MONTGOMERY COUNTY HISTORIC PRESERVATION COMMISSION
STAFF REPORT

Address:	402 Tulip Avenue, Takoma Park	Meeting Date:	10/23/2019
Resource:	Contributing Resource Takoma Park Historic District	Report Date:	10/16/2019
Applicant:	Tony Camilli	Public Notice:	10/9/2019
Review:	HAWP	Tax Credit:	n/a
Case Number:	37/03-19SS	Staff:	Dan Bruechert
PROPOSAL:	Window installation (retroactive), sill replacement, and soffit restoration

March 27, 2019 Preliminary Consultation Staff Report

INSTALLED WINDOWS

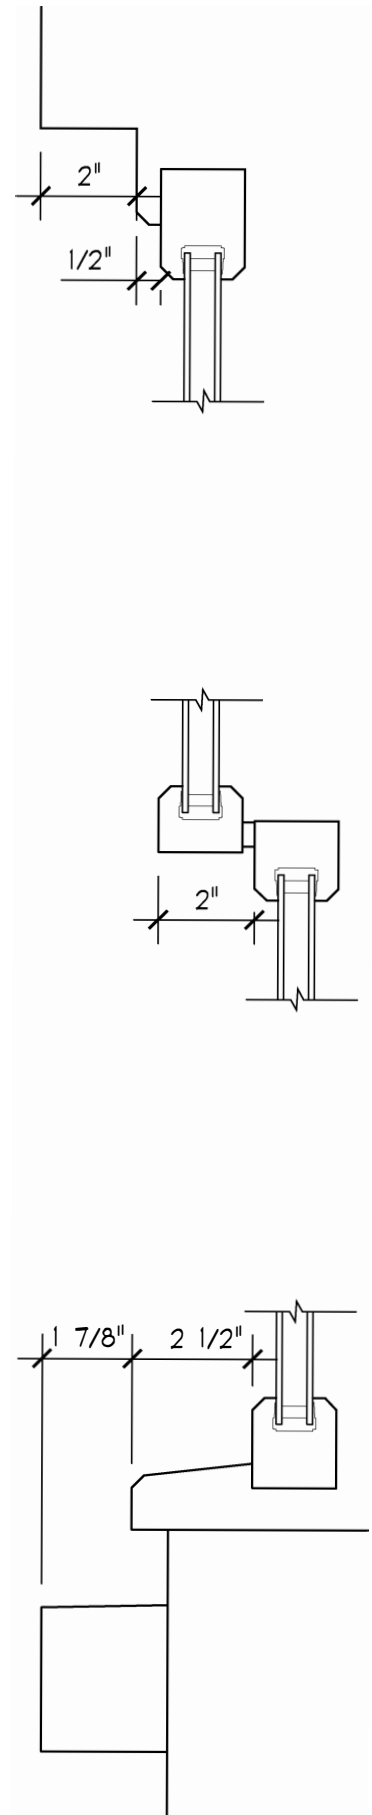
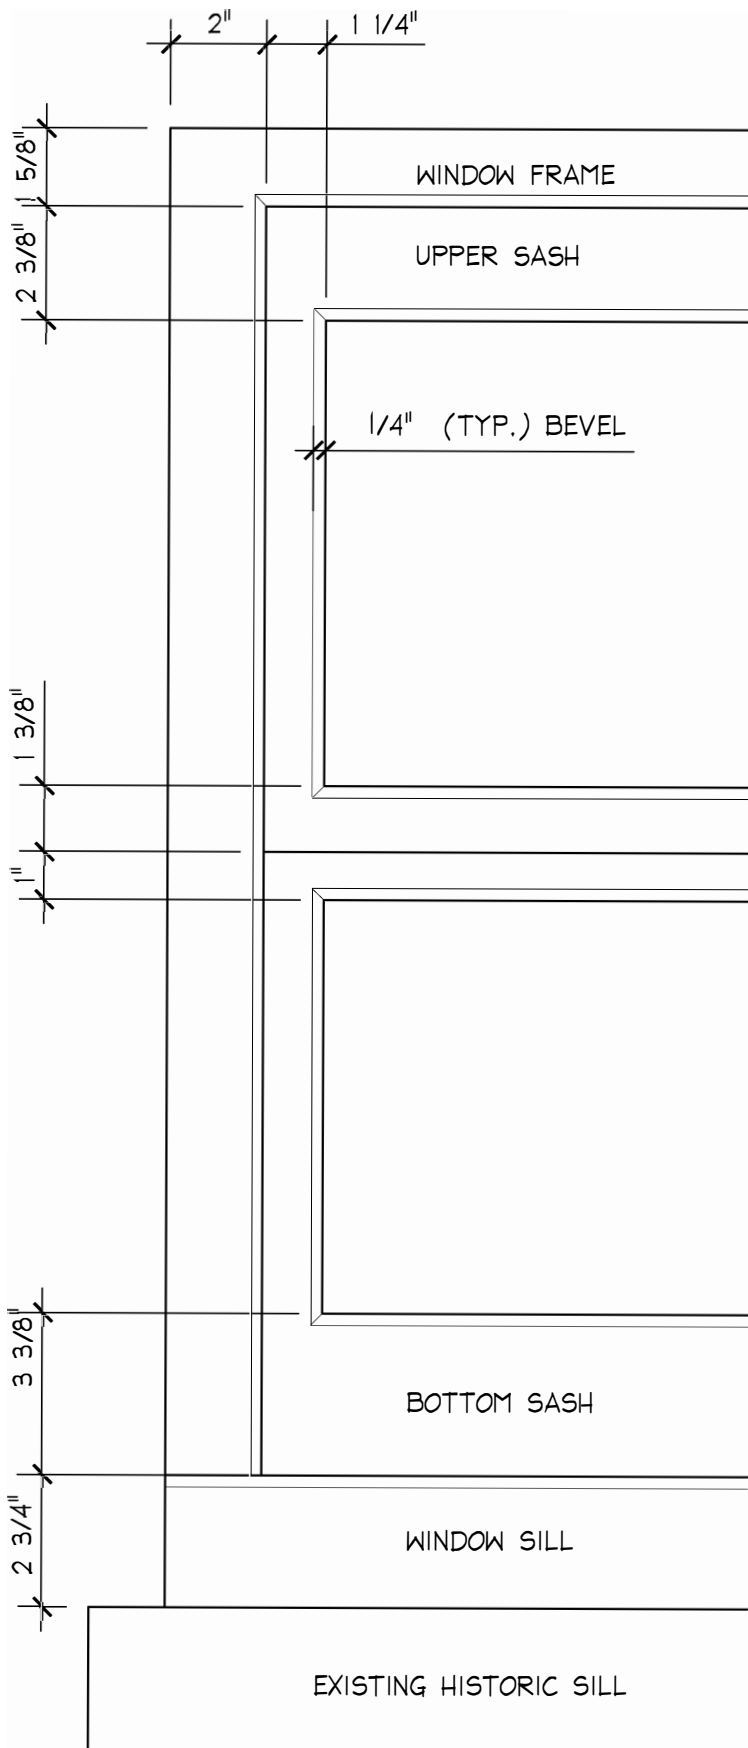
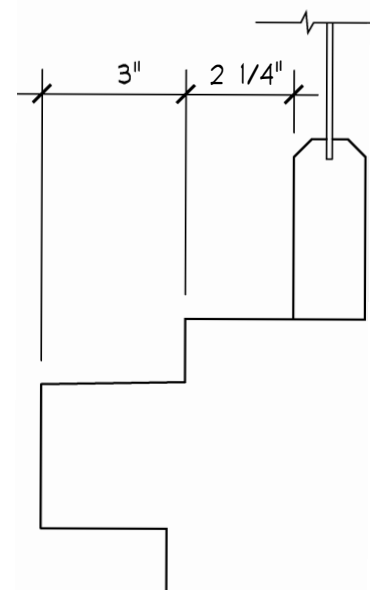
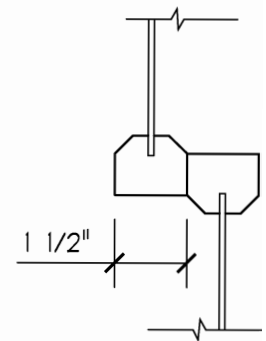
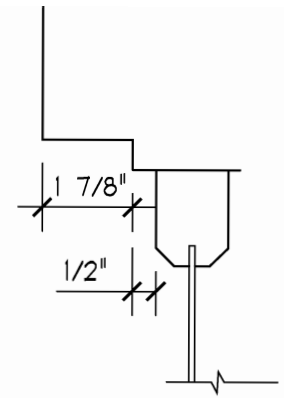
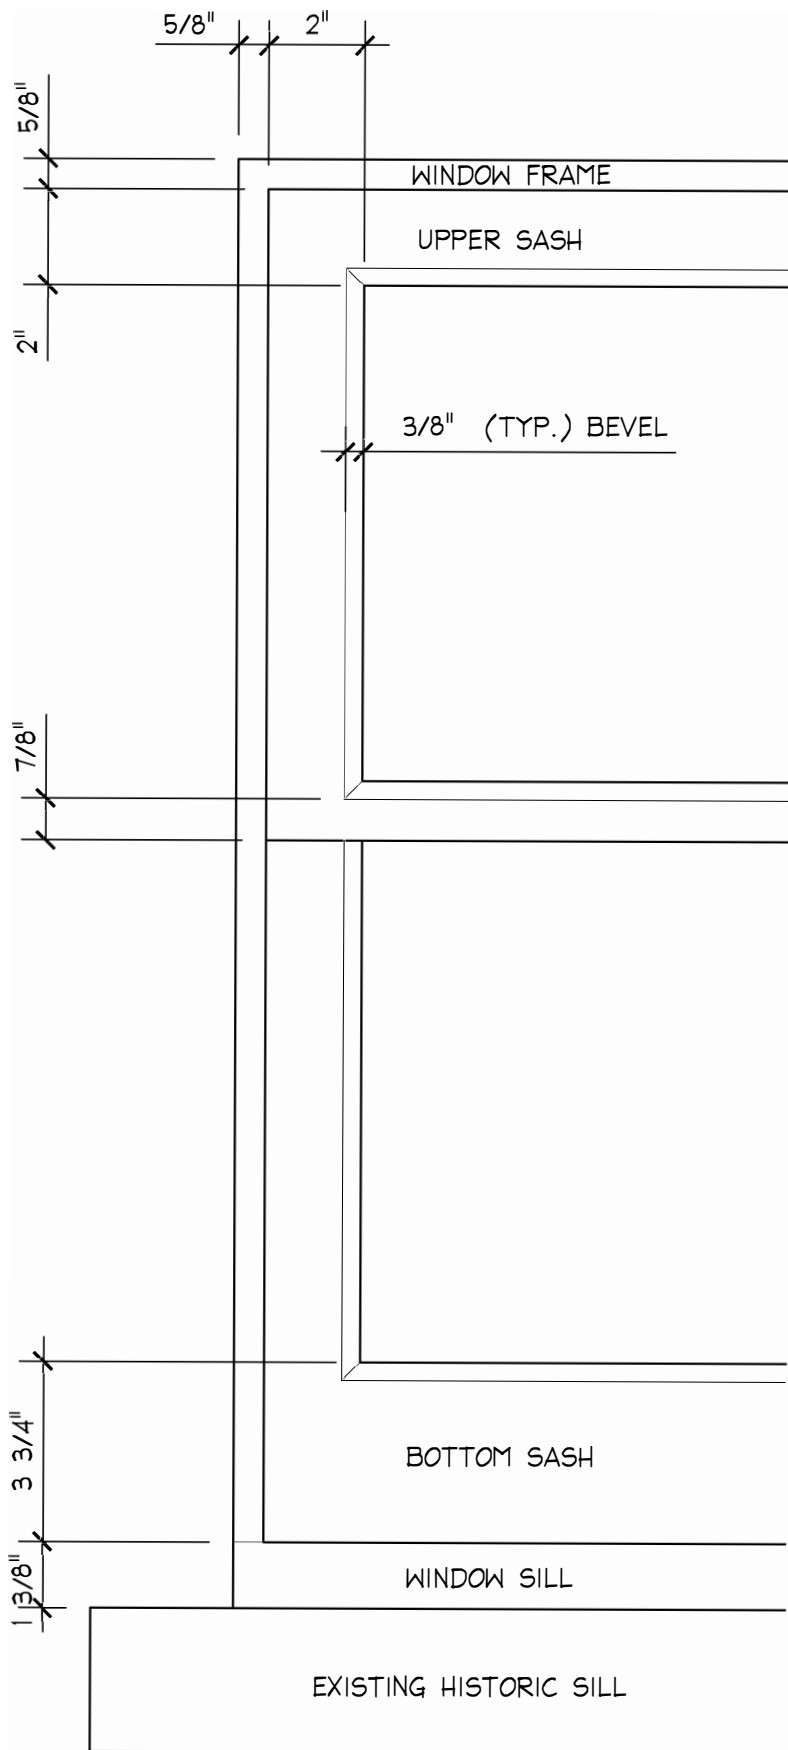
The second issue with the work undertaken was that the new windows do not match the dimensions of the historic wood windows. This was verified on site, however, a comparison of the two windows was not necessary, as the historic windows were installed traditionally with sash cords or chains, and the new windows utilize jamb liners. By Staff's estimate, this had the effect of narrowing each sash by approximately 2" (two inches). That amount may not seem significant, but most of the windows facing the street are either in a pair or are tripled, effectively multiplying the visual effect of the narrower sashes. The tri-partite sash window on the second floor now has an additional 6" (six inches) of solid surface.

Although these windows were replaced, the replacement sashes and fixed window in the attic made by Weather Shield are also made of solid wood and in the exact same style as the prior sashes (i.e. 1 over 1). Attached hereto and marked as Exhibit 1 are drawings from our architect showing the measurements for these Weather Shield wood replacement sashes. As shown in the drawings, the replacement sashes measure very closely in size to our neighbor's windows, which are the closest approximation to our prior windows.

requiring the removal of another set of windows from the subject property and dumping them in the landfill. The windows at issue were custom fabricated, which means that they cannot be returned and will not be re-used. Their only destination would be the trash. Staff recommends approval of the replacement windows under 24A-8(b)(6).

EXHIBIT 4

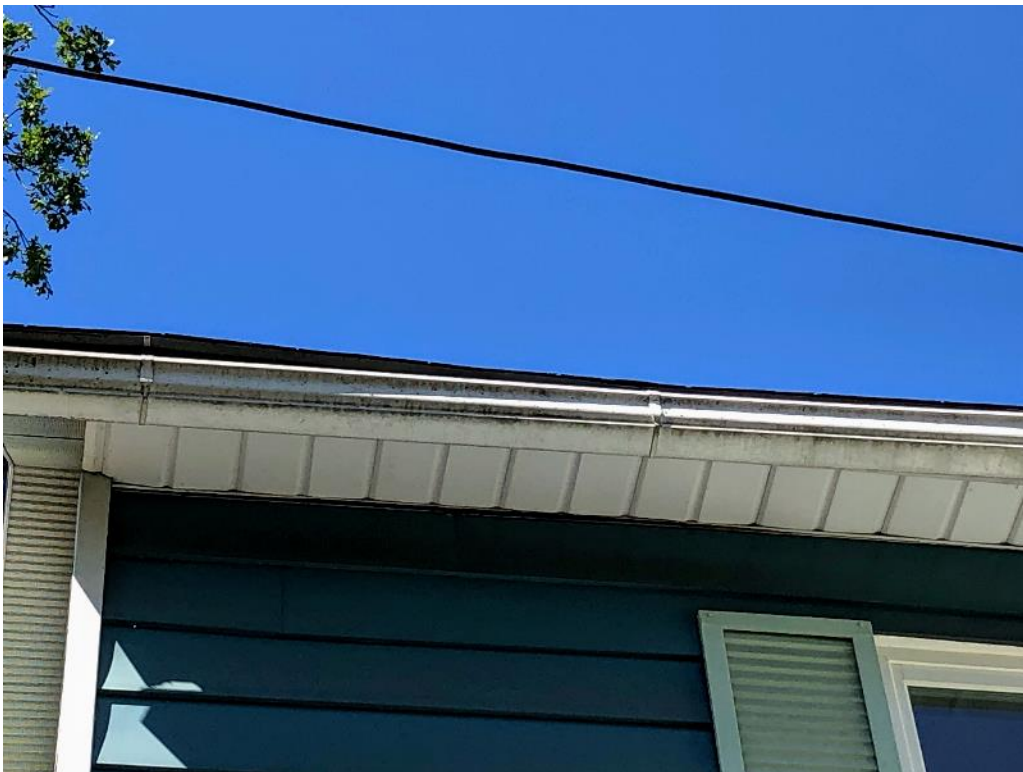
The exiting soffit was wrapped in aluminum siding, likely the same time that the house was covered in aluminum. As part of the gutter replacement, the applicant proposes to remove the aluminum siding and restore the wood soffit. The aluminum soffit is not a historic material, so its removal should be approved as a matter of course. The replacement of this feature in wood will only bring the appearance of the house closer to its historic appearance. Staff finds that this is an improvement of the appearance of the house and recommends approval under the *Design Guidelines*, and Chapter 24A-8(b)(1) and (2).

View of non-historic aluminum eave soffit

View of non-historic aluminum eave and rake soffits

View of non-historic aluminum rake soffit

View of non-historic aluminum soffit and new wood soffit for addition
